## Response To Submissions

To	Sara Roach	Page	1
CC	Elise Crameri		
Subject	Glebe Island Expo Response to Submissions		
From	Russell Yell		
File/Ref No.		Date	14-Feb-2013

The following tables list the transport and access related submissions received during exhibition of the Glebe Island Expo Development Application and the response to those submissions.

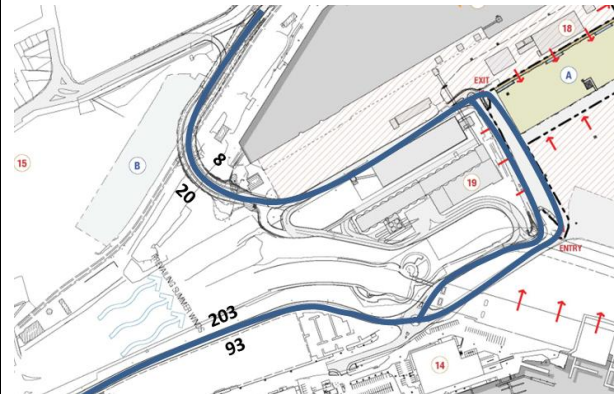
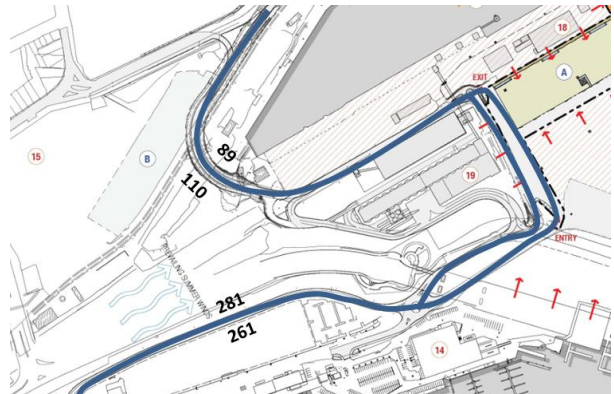
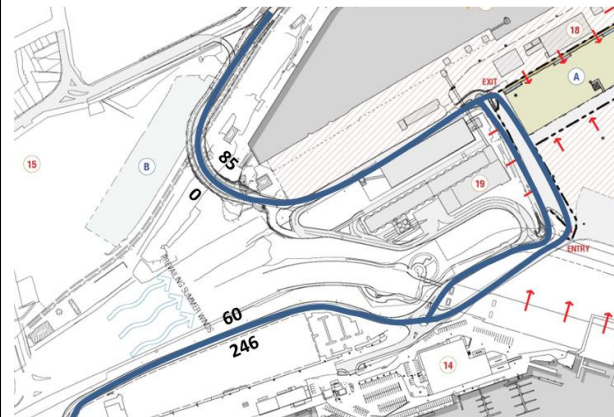
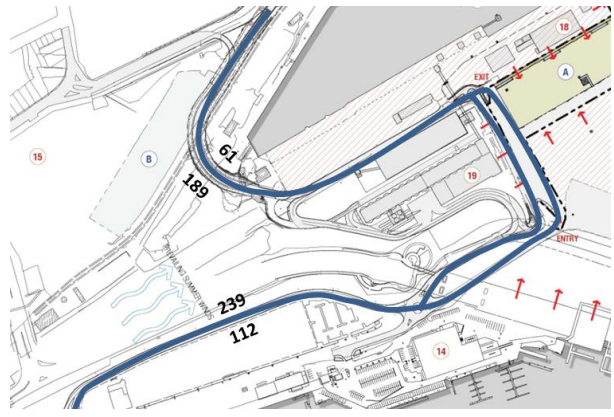
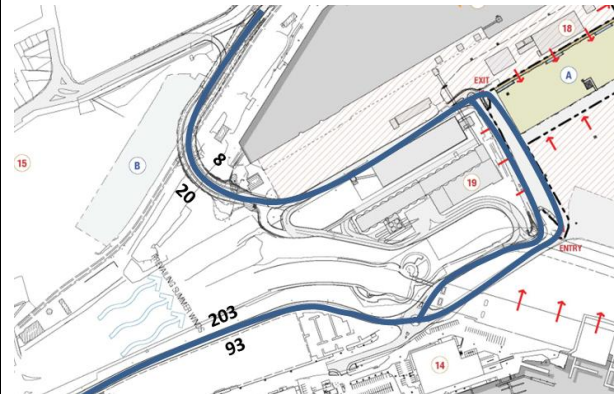
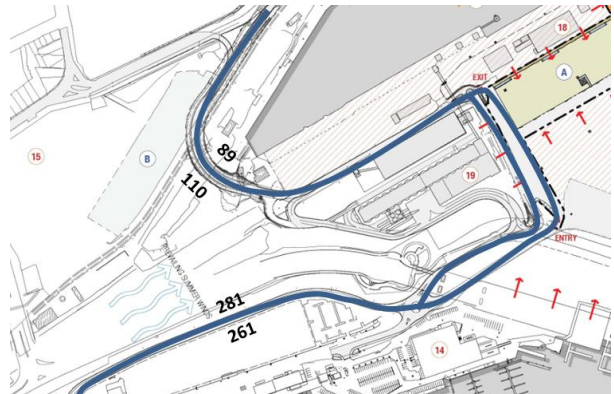
2.2		<p>Traffic and access:</p> <ul style="list-style-type: none"> <li>i. Pedestrian and bicycle access to the Interim facility will not be permitted by Sydney Ports</li> <li>ii. Charter bus drop off zones outside the site boundary will not be permitted</li> <li>iii. All bus drop off/pick up locations must be within the site boundary.</li> <li>iv. TMS does not address internal traffic flow within the Glebe Island precinct.</li> <li>v. Traffic movement from existing Glebe Island port tenants need to be included in the traffic assessment.</li> </ul>	<p>i, ii &amp; iii. The site layout plan has been revised in light of these comments.</p> <p>iv. Refer to 3.3 in regards to internal traffic flow.</p> <p>v. Traffic movements from existing Glebe Island port tenants have been accounted for in the traffic survey located at the intersection of The Crescent / James Craig Roads, which were used in the traffic assessment.</p> <p>RMS traffic data along Sommerville Road (refer to image to the left) was provided to INSW by Sydney Ports. It was assumed majority of the two way volume counts provided by RMS are heavy vehicles associated with existing Glebe Island port tenants.</p> <p>The table below provides a comparison of heavy vehicles between the traffic counts used in the report and RMS traffic data.</p>

Item	Reference	Comment	Response																					
		<p><b>RMS traffic data along Sommersville Road</b></p> 	<p>As shown below, the traffic survey recorded a higher number of heavy vehicles during the weekday, which confirms that the traffic movements associated with the existing Glebe Island tenants have been included in the assessment.</p> <p>The traffic survey weekend peak recorded slightly lower heavy vehicles than RMS data; however this will have minimal impact on the traffic assessment reported.</p> <table><tr><th colspan="3">The Crescent / James Craig Road (heavy vehicles)</th></tr><tr><th>Peak period</th><th>Reported Traffic Survey</th><th>Avg RMS traffic data</th></tr><tr><td>AM Peak</td><td>47</td><td>24</td></tr><tr><td>Mid Peak</td><td>49</td><td>19</td></tr><tr><td>PM Peak</td><td>16</td><td>13</td></tr><tr><td>Weekend Peak</td><td>5</td><td>6</td></tr></table>	The Crescent / James Craig Road (heavy vehicles)			Peak period	Reported Traffic Survey	Avg RMS traffic data	AM Peak	47	24	Mid Peak	49	19	PM Peak	16	13	Weekend Peak	5	6

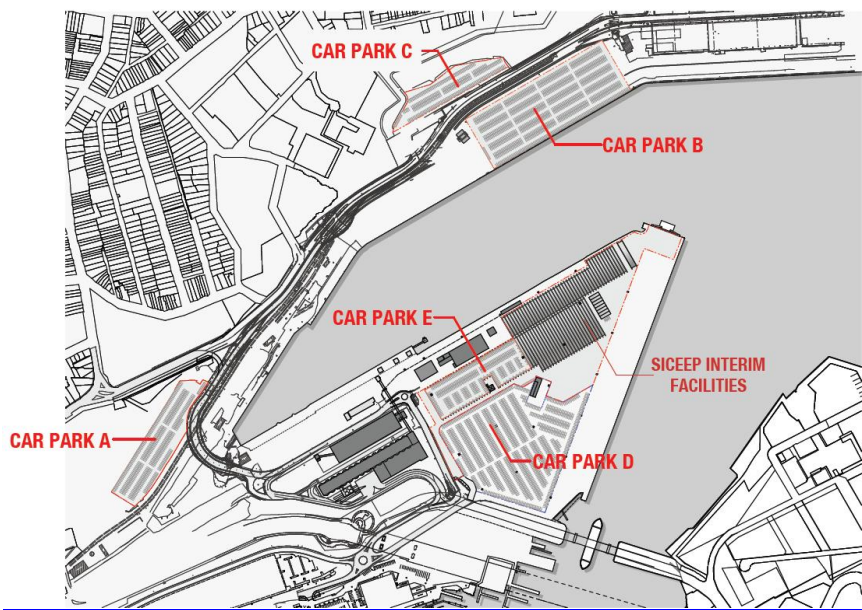
3.2		<p>The following concerns were raised:</p> <ul style="list-style-type: none"><li>i. Minimal improvements are proposed to key local intersections</li><li>ii. The additional traffic impact on queue lengths at local intersections has not been reported</li><li>iii. Traffic impacts (queuing) may affect the local community</li></ul>	<p>Traffic modelling results shows the intersections assessed operate at an acceptable level of service (LoS D or better). The level of service is a measure of the overall performance of the intersection, refer to table below.</p> <table><tr><th>Level of Service</th><th>Ave. Delay (secs/veh)</th><th>Traffic Signals and Roundabouts</th></tr><tr><td>A</td><td>Less than 14</td><td>Good operation</td></tr><tr><td>B</td><td>15 to 28</td><td>Good with acceptable delays and spare capacity</td></tr><tr><td>C</td><td>29 to 42</td><td>Satisfactory</td></tr><tr><td>D</td><td>43 to 56</td><td>Operating near capacity</td></tr><tr><td>E</td><td>57 to 70</td><td>At capacity; at signals incidents will cause excessive delays</td></tr><tr><td>F</td><td>&gt;70</td><td>Roundabouts require other control mode</td></tr></table> <p>Source: Guide to Trip Generating Development, RTA 2002</p> <p>The modelling approach adopted assessed the overall relative impact of the proposed development along with the cumulative impact of surrounding developments. The traffic assessment showed that as a result of additional traffic, the</p>	Level of Service	Ave. Delay (secs/veh)	Traffic Signals and Roundabouts	A	Less than 14	Good operation	B	15 to 28	Good with acceptable delays and spare capacity	C	29 to 42	Satisfactory	D	43 to 56	Operating near capacity	E	57 to 70	At capacity; at signals incidents will cause excessive delays	F	>70	Roundabouts require other control mode

Item	Reference	Comment	Response																												
			key intersections assessed experienced a minimal increase in average delays.

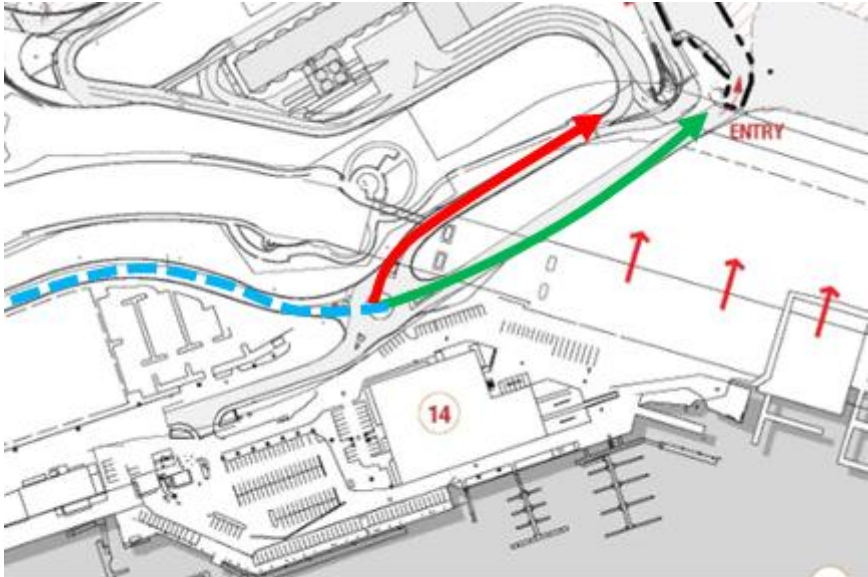
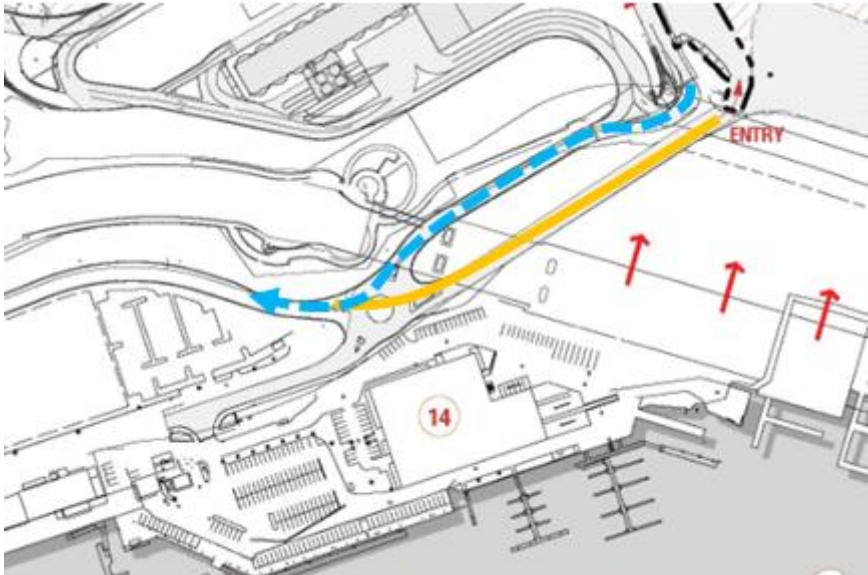
Glebe Expo	CPT	Rozelle Village	Software	TRANSYT	SIDRA	Paramics	Traffic surveys	Sept 2012	Feb 2010 / May 2010	Oct 2010
	Glebe Expo	CPT	Rozelle Village												
Software	TRANSYT	SIDRA	Paramics												
Traffic surveys	Sept 2012	Feb 2010 / May 2010	Oct 2010												
7.3		<p>The Robert Street link is not subject to an assessment regarding the increased traffic, including the intersection of Robert and Mullens Streets. There is also a serious question regarding the practicality of enforcing a left out only turn at the Robert Street egress.</p>	<p>The temporary Robert Street link will be utilised when vehicles are exiting the Interim facility, the majority of which will occur during the PM, which is against the peak direction flow along Robert Street.</p> <p>As shown in Appendix B, the swept path analysis of the proposed Robert Street link shows vehicles are capable of using the left out only link. Traffic controls and measures will be required to ensure proper use of the link.</p>												
7.4		<p>Construction Traffic Impacts have not been considered and may be concurrent with other site construction periods.</p>	<p>This has been mentioned, but the exact construction method is not yet known, so cannot be assessed. This will be the responsibility of the proponent once the construction method has been defined.</p>												
7.5		<p>On-street parking in the surrounding road network and the potential for intrusion of event parking on adjacent roads and car parks has not been considered.</p>	<p>Noted, it is proposed temporary residential parking schemes could be adopted when events are held. Refer to 3.6.</p>												
7.6		<p>Increased demand for event public transport when a cruise ship is docked (as a result of reduced car parking supply at the cruise terminal car parks with event trips required to be by public transport) has not been considered.</p>	<p>Noted, however CPT operates at different times to events.</p>												
7.7		<p>The DA includes a narrow coverage of public transport resulting in a missed opportunity for commercial patronage in Leichhardt LGA.</p>	<p>Noted, however public transport provision for the Interim Facility will only cater for patrons as part of the DGR. Consideration of extending services to cater for the Leichardt LGA will only increase pressure on parking, the number of services provided and pedestrian accessibility. The proposed public transport (charter and shuttle services) is for event days only.</p> <p>With the restriction of pedestrian and bicycle access to the Interim Facility, it is not practical to allow local residents to use ferry services at the temporary wharf since bus/ferry services will only be provided when events are held at the</p>
